Re: Trestle Trail, Coventry Rhode Island  
Response to Remedial Action Work Plan (RAWP) Comments September 20, 2012

Vanasse Hangen Brustlin Inc. (VHB), on behalf of our client, Prime Engineering, Inc. (PEI), submits this letter to respond to comments dated September 20, 2012 regarding the Trestle Trail Remedial Action Work Plan (RAWP).

TYPICAL SECTION OF PROPOSED SHARED-USE PATH  
 IN AREA WHERE CONTAMINATED SOIL IS REUSED  
 (CAMP WESTWOOD ROAD)

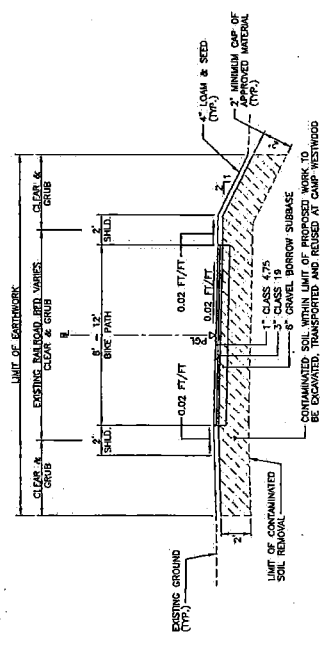
2. *Please provide a site figure that illustrates a cross-sectional example of the bike path's width. This figure should show how wide the capping scenario will extend and how the cap will taper off, if applicable to the undisturbed ground.*

3. *Please provide a site figure showing the locations of soil samples with respect to the areas to be excavated and/or capped. The soil sampling locations, specifically locations that have exceedances of the Residential Direct Exposure Criteria and locations that are to be used as points of compliance, should be included in the site figures to distinguish*

The enclosed figures replace those previously provided in Appendix B. These include a "Typical Section Plan" which shows two typical cross sections. One is a typical section of the proposed shared-use path in an area of contaminated soil. The other is a typical section of proposed shared-use path in an area where contaminated soil is being reused under a cap to raise surface grades. In all areas, where impacted soil remains, a minimum of two foot of clean fill will be used for capping.

PLAN NO. 1

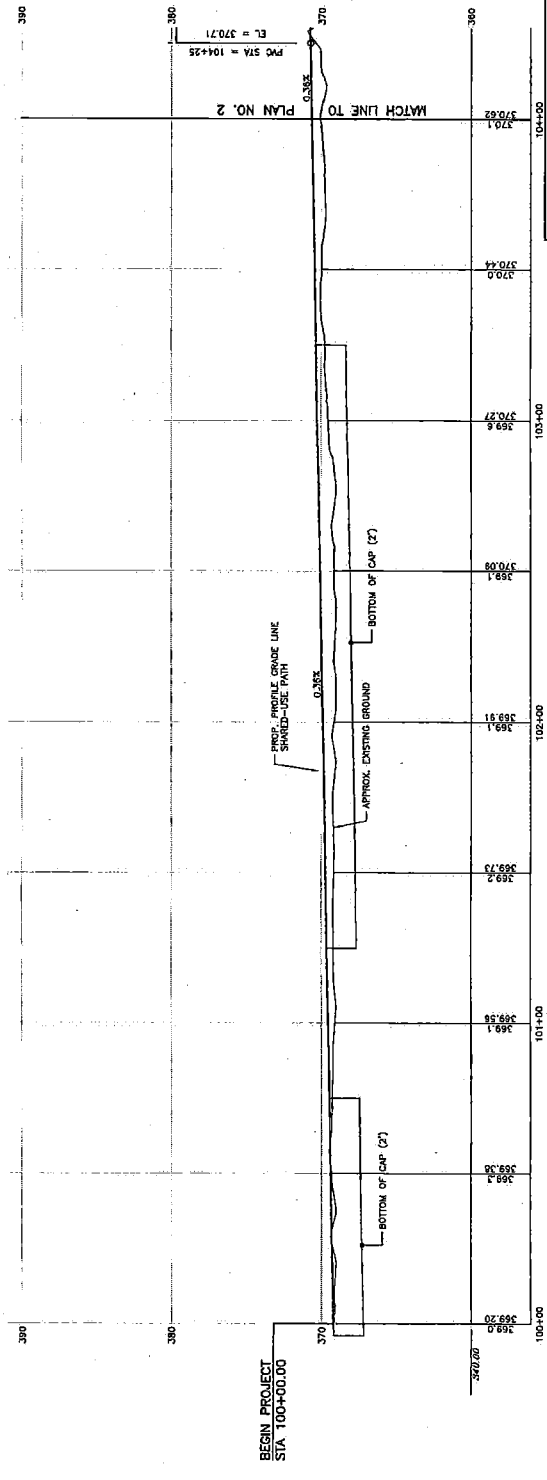
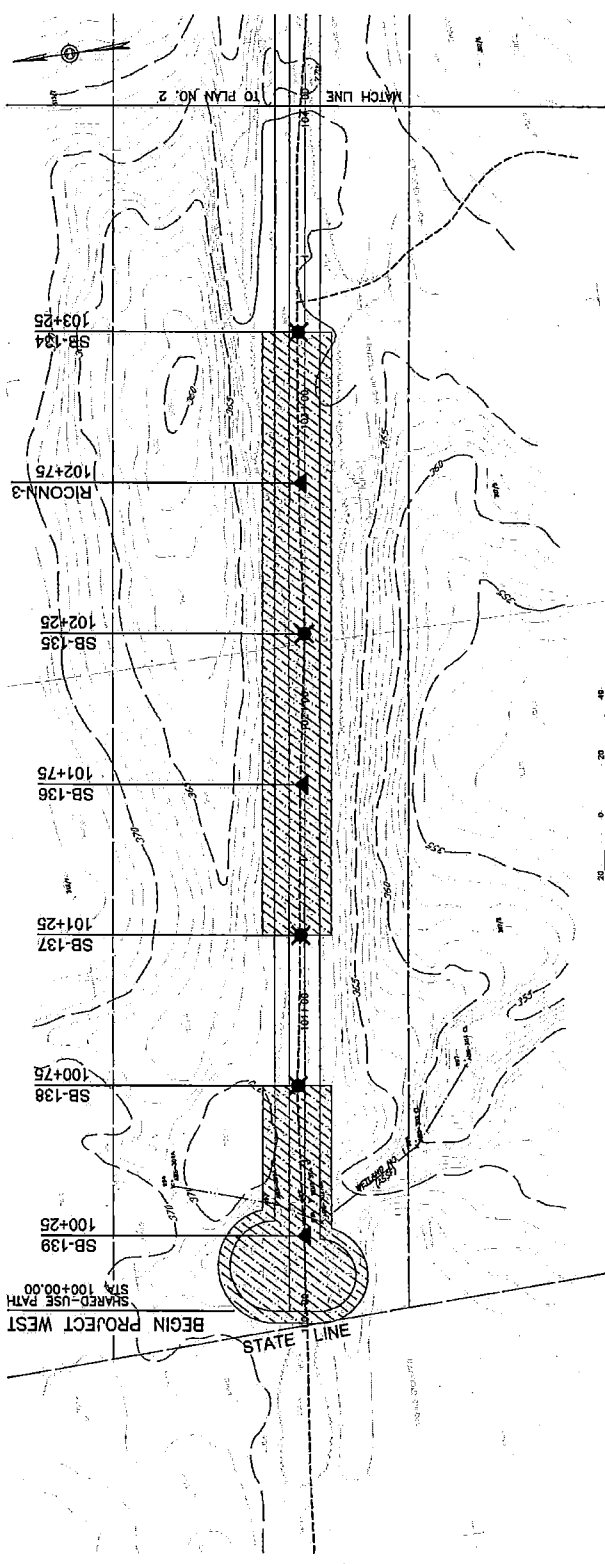
6. *Appendix B – Construction Plans lists certain areas outside the actual future bike path as "approximate location of excavation of contaminated soil..." These areas are defined specifically on plan numbers 1 & 5-11. Please provide more details as to the type of remediation (i.e. capping and/or excavation followed by compliance sampling) that will be implemented in these areas.*

Plans 1 through 11 show the sections of trail, their corresponding impacted and compliance point locations, and the extent of soil to be removed as requested.

All areas will either be cut or filled based on the required grade elevations. Although four capping scenarios are set forth in the RAWP, the preferred method to be used is capping with two feet of clean fill overlying impacted soil in all instances where it is possible. Final trail cover material will be placed over the two feet of clean material. The other capping options remain in the RAWP in the unlikely event that unexpected field conditions require an alternative approach to the preferred method. Please refer to the drawings provided in Appendix B of the revised RAWP.

PLAN NO. 7

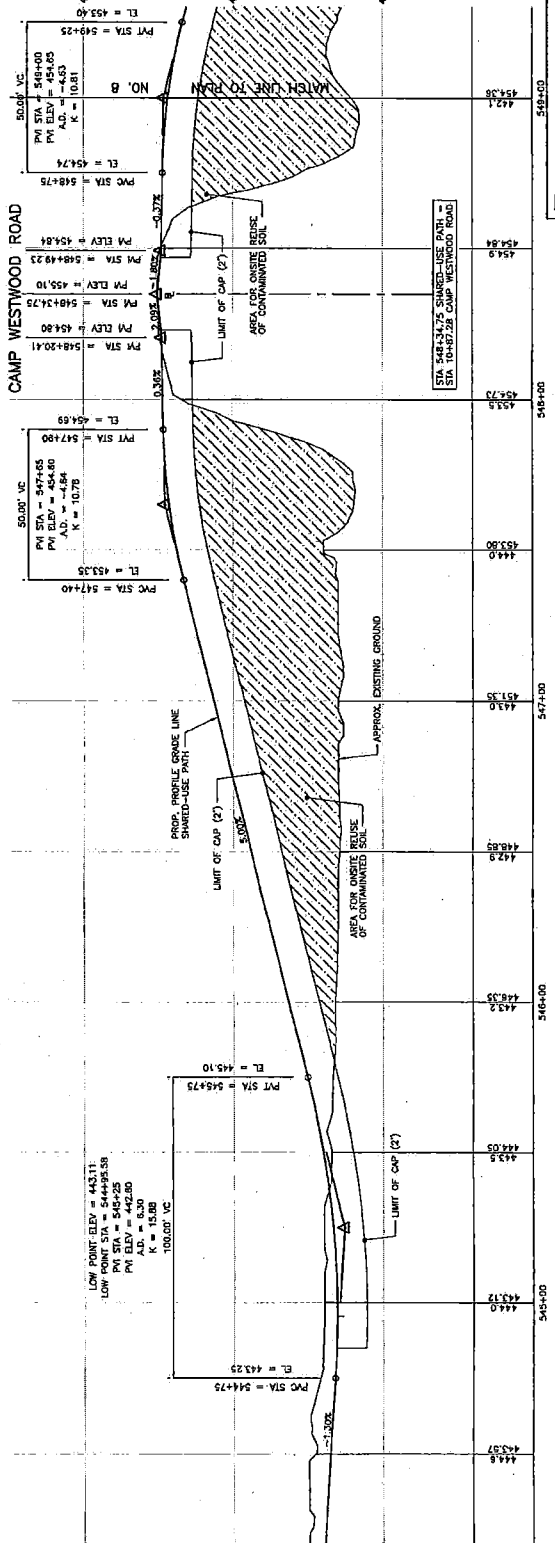
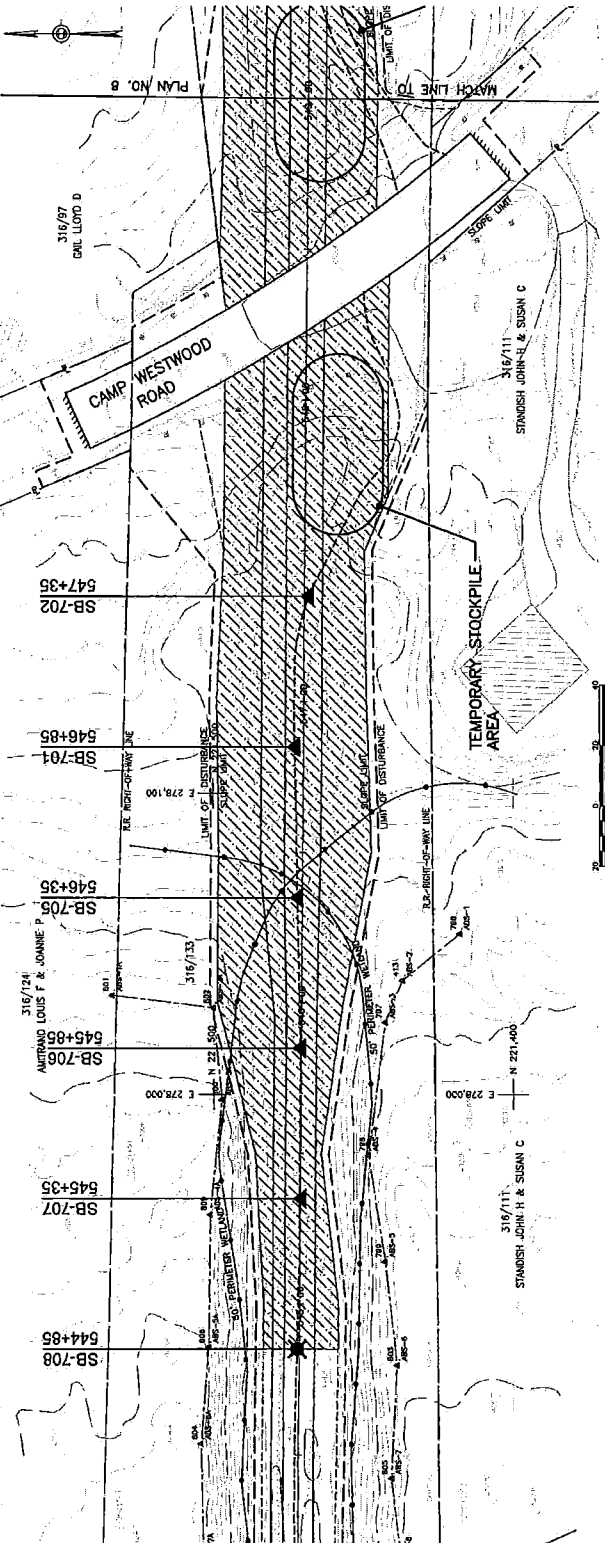
5. *Page 15 Soil Stockpile Management of the RAWP states that "proposed stockpile locations are shown on the attached plans in Appendix B." However, Appendix B does not depict the temporary stockpile locations for contaminated soils. Please revise the figures in Appendix B, or generate new figures, that show the locations for temporary soil stockpiles.*

These areas are shown on the new figures provided in Appendix B.
